LANDSCAPE PEER REVIEW - Memo 3

NPDC_ SUB21/47781 & LUC22/48312 **DATE_**27 Feb 2023

SUBJECT_ Peer Review Commentary

of an application under s88 of the Act by B, M R Sim to the New Plymouth District Council to undertake a boundary change and five-lot subdivision, at 6 & 42 Leith Road, Okato (SUB21/47781)

Photo 2: Image of vegetation and sign on the opposite side of Leith Road, north of the subject site.

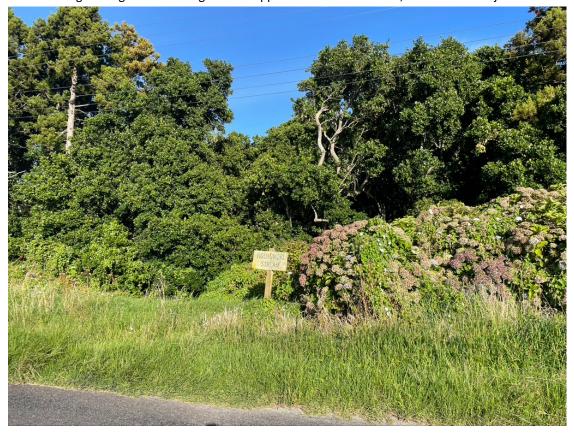
Please also note (as per my original memo) that there is a swale within Lot 1 which directs overland flow to the Maitahi Stream [The sign name of the stream entitles it Ngutumoki Stream]. A culvert pipe in the adjacent property carries water beneath the road to the stream. This area is covered by LUC 1 in the LRI. This stream feeds into a QEII and regionally significant wetland. Land use, dwelling development, and land management should take account of this critical source area as per the NPS-FW and avoid activities that may adversely affect the corresponding waterway in the future. This information could be included as an advice note. See photos and aerial attached.
